UNITED STATES DEPARTMENT OF COMMERCE United States Patent and Trademark Office Address: COMMISSIONER FOR PATENTS P.O. Box 1450 Alexandria, Virginia 22313-1450 www.uspto.gov

| APPLICATION NO.                              | FILING DATE                        | FIRST NAMED INVENTOR | ATTORNEY DOCKET NO. | CONFIRMATION NO. |
|--|------------------------------------|----------------------|---------------------|------------------|
| 10/501,809                                   | 07/20/2004                         | Jerker Lundgren      | ALBIHN W 3.3-454    | 6597             |

|  | Application No.   | Applicant(s)     |  |  |  |
|--|---|------------------|--|--|--|
| Office Action Comments   | 10/501,809  | LUNDGREN, JERKER |  |  |  |

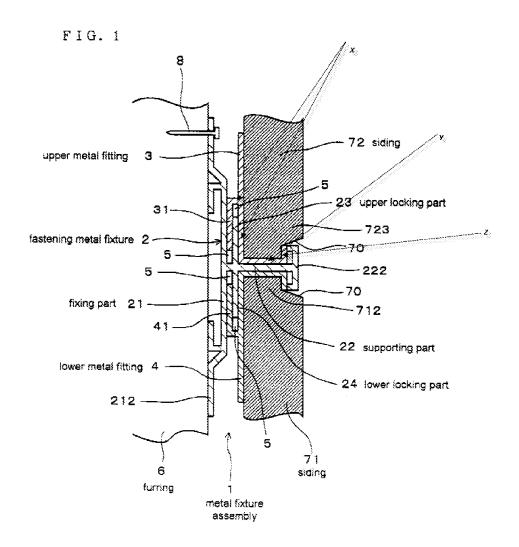
Claims 12-13: Watanabe discloses the glazing system of claim 9, wherein said at least one retaining element is substantially U-shaped and has a coupling organ engagement portion (X, see below), a waist portion (Y), and a flange portion (Z), wherein said coupling organ engagement portion contacts a surface of said facade proximate to said coupling organ, said flange portion contacts a surface of said facade remote from said coupling organ, and said waist connects said coupling organ engagement portion with said flange portion and is configured to traverse said facade at a side edge thereof (figure 1); and wherein said at least one retaining element is composed of a hard material.

Watanabe does not disclose that said coupling organ engagement portion and said flange portion of said of said at least one retaining element each taper away from an opposing surface of said facade at a side edge thereof, and said flange portion of said at least one retaining element is biased in a direction toward said facade, thereby defining a void between said facade and said coupling organ engagement and flange portions of said at least one retaining element. However, it is notoriously common and well known to have gripping elements (such as the flange and organ engagement portion) taper thereby defining a void. It would have been obvious to one of ordinary skill in the art at the time the invention was made to modify the elements of Watanabe to have the taper fit thereby creating a friction fit to provide a more secure connection and a tighter fit.
